**COMMITTEE OF ADJUSTMENT REPORT
MINOR VARIANCE APPLICATION
A037/22
17 Winterlude Ct Kleinburg**

ITEM NUMBER:	CITY WARD #: 1
APPLICANT:	Luigi & Loredana Guarascio
AGENT:	Andre Grisolia
PROPERTY:	17 Winterlude Ct Kleinburg
ZONING DESIGNATION:	See below.
VAUGHAN OFFICIAL PLAN (2010) DESIGNATION:	Vaughan Official Plan 2010 ('VOP 2010'): "Low-Rise Residential"
RELATED DEVELOPMENT APPLICATIONS:	None
PURPOSE OF APPLICATION:	Relief from the Zoning By-law is being requested to permit the construction of a proposed loggia, cabana and retaining wall to be located in the rear yard.

DRAWING NUMBER: SP-1

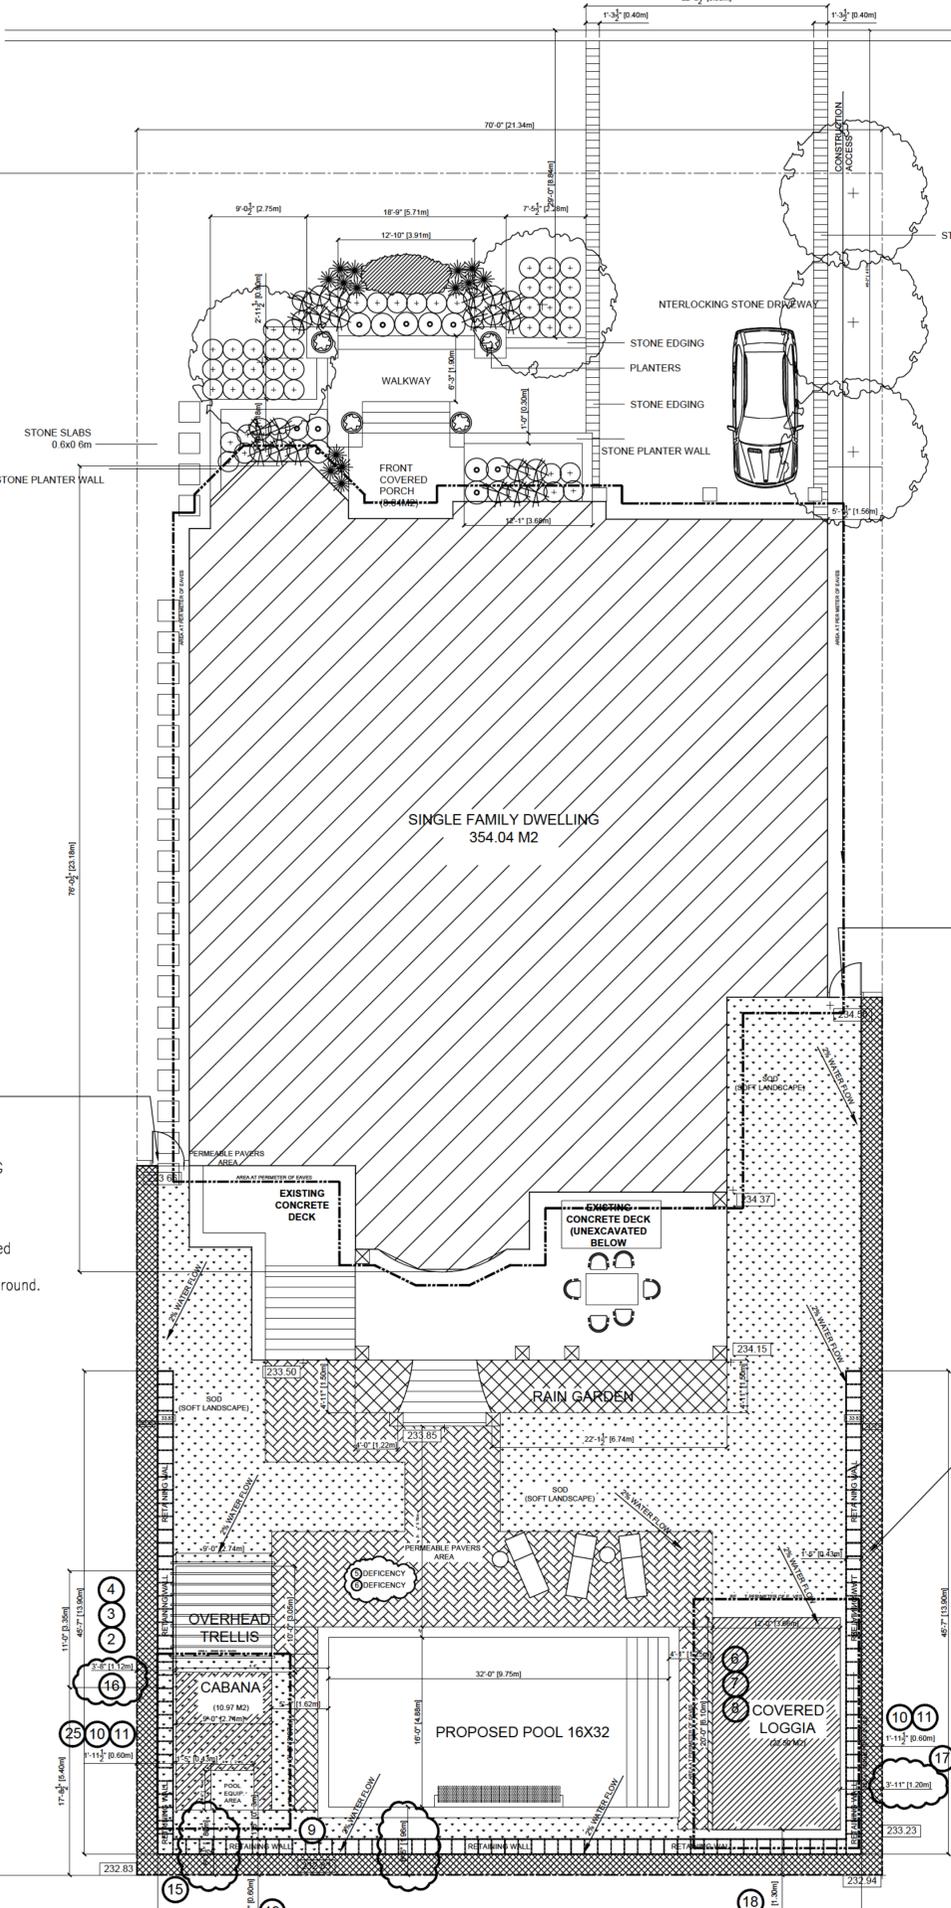
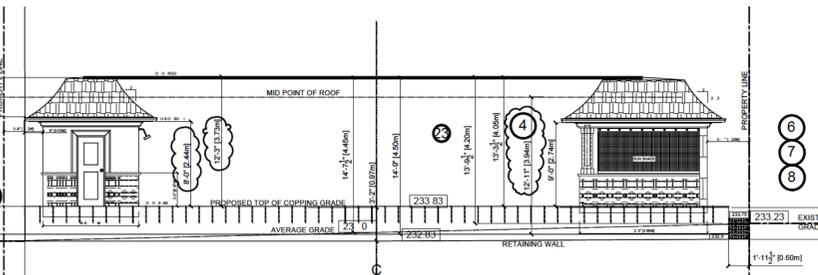
Proposed Loggia shows some type of fireplace under the Flat Screen TV Comment: There is not note to the type of fuel. Electric, natural Gas, or propane. No solid fuel burning unit and chimney to be permitted

Upon recommendations from the Development Planning Department, the Owners have revised their application to reduce the height of the proposed covered loggia. The Development Planning Department has no objection to Variances 5, 7, 8, 17 and 18 for the proposed covered loggia consistent with previous approvals in the neighbourhood and are not anticipated to create adverse visual impact to the adjacent properties. All proposed setbacks also maintain an appropriate area for access and drainage.

Upon recommendations from the Development Planning Department, the Owners have revised their application to reduce the height of the proposed cabana. The Development Planning Department has no objection to Variances 2, 3, 4, 15, 16 and 20 for the proposed cabana. The increase in height under Zoning By-law 1-88 is to keep a consistency between the top of the roofs for the cabana and the covered loggia. The rear yard has an uneven elevation which creates the disparity in the requested variances for the two structures. Height under Zoning By-law 01-2021 is measured at average grade, meaning there is no such discrepancy for the variances under Zoning By-law 01-2021. The cabana would have the same visual impact to the neighboring properties as

The Development Planning Department has no objection to Variance 9 for the proposed retaining wall as the Owners have revised their application to reduce the height of the wall to 1.0 m upon recommendations from the Development Engineering Department. The Development Engineering Department has reviewed the revised site plan and elevations and have no concerns.
